Access Compliance Report

Public Rights-of-Way

Intersection ID: 30433	Main Street: CEDAR_ROCK_DR	Cross Street: NANNYBERRY_LN	Location: SW
ADA ID: 4B1EC22D55B8	Ramp Type: PerpDiag	Initial Pass/Fail: Pass	Overall Compliance: No
			Severity Score: 25
Codes/Mitigation Info/Possible Solution		Field Measurements/Component Compliance

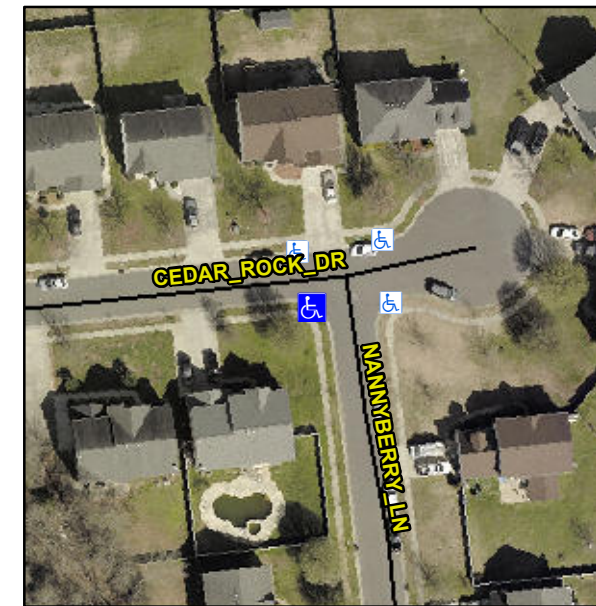
Not Found, R304.2.1, R304.2.2-Perp, R304.3.2-Para, R304.5.3, R305, R304.5.4

Compliance	Description	Data	Compliance	Description	Data
N/A	Ramp Length (in)	95.0	Yes	Ramp Slope (%)	5.1
Yes	Ramp Width (in)	49.0	Yes	Ramp XSlope (%)	1.4
N/A	Flare Type LT	Sloped	N/A	Flare Type RT	N/A
N/A	Flare Slope LT (%)	0.6	N/A	Flare Slope RT (%)	6.7
N/A	Flare Traversable LT?	No	N/A	Flare Traversable RT?	No
No	Landing Length (in)	N/A	No	DWS Provided?	No
No	Landing Width (in)	N/A	N/A	DWS Contrast?	No
No	Landing Slope (%)	N/A	N/A	DWS Length (in)	N/A
No	Landing X Slope (%)	N/A	N/A	DWS Full Width?	No
N/A	Landing Curb? (Y/N)	No	N/A	DWS Offset (in)	N/A
N/A	Shared Landing?	No			
Yes	Gutter Ponding?	No	No	Gutter Slope (%)	5.2
Yes	Gutter Lip Ht (in)	0.0	No	Gutter X Slope (%)	2.3
N/A	Painted X Walk1?	No	N/A	Painted X Walk2?	No
	X Walk 1 Direction	To E		X Walk 2 Direction	To N
N/A	X Walk 1 Width (in)	N/A	N/A	X Walk 2 Width (in)	N/A
	X Walk 1 Slope (%)	2.5		X Walk 2 Slope (%)	3.0
	X Walk 1 X Slope (%)	3.7		X Walk 2 X Slope (%)	0.5

N/A	Ramp inside XWalk1?	N/A	N/A	Ramp inside XWalk2?	N/A
	Road Slope (%)	2.3	N/A	Clear Space?	Yes
	Road X Slope (%)	3.7	N/A	Clear Space to XWalk (in)	N/A
Yes	Any Obstructions?	No	Yes	Storm Grate/Utility Hazard?	No
	Obstruction Type			Storm Grate/Utility Type	
		N/A			N/A
			Yes	Surface Condition? (G/P)	Good

Remove & Replace Curb Ramp With Two New Directional Ramps or Equivalent. Remove & Replace Gutter.
